Re: Applicant - GBRSTORZ, LLC
Resubdivision of Anderson Sunnyside Farm
318 Kings Highway

Our response letter dated October 21, 2020 was prepared and provided to address your review comments dated 09/18/2020 with a Date of Meeting: 09/23/2020.

Upon review, additional information is required as described in your review comments with Date of Meeting of 10/28/2020.

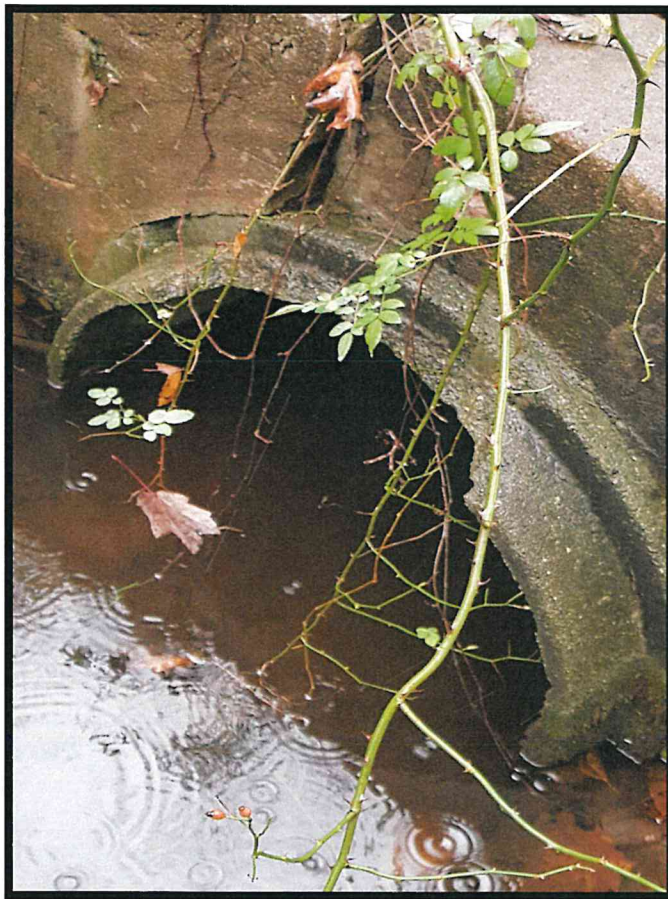
- 2. *The proposed design plans show a direct connection of the site drainage to an existing Town drainage system in Hartford turnpike. Calculations must be provided to show that this drainage system has adequate capacity to properly convey drainage from this site. Analysis of this system should extend to the system outfall, and include an assessment of the ability of downstream channels and features to convey post development flows.*

The Developer's Engineer has surveyed the existing drainage system on Hartford Turnpike, and performed an analysis of existing and proposed drainage conditions. The analysis indicates that the existing drainage system exceeds capacity downstream of the connection point from this development for even a two-year storm event. The proposed development will generate an approximately 5% greater peak site runoff for all storm events analyzed. Since the existing drainage system lacks available capacity to accommodate this increase in site runoff, additional mitigation measures will be needed. In addition, no evaluation of condition downstream of this outfall was provided.

The drainage outlet consists of a 30" RCP pipe from a concrete headwall. A large crack exists in the headwall above the concrete pipe. A portion of the top of pipe exposed through the headwall has broken off. Silt, sediment & debris are visible at the outlet and downstream of the pipe which is limiting flow. At the time of inspection, the pipe was half full of water. It appears that a sink hole exists above the pipe approximately 10 feet west of the outlet (see pictures below).
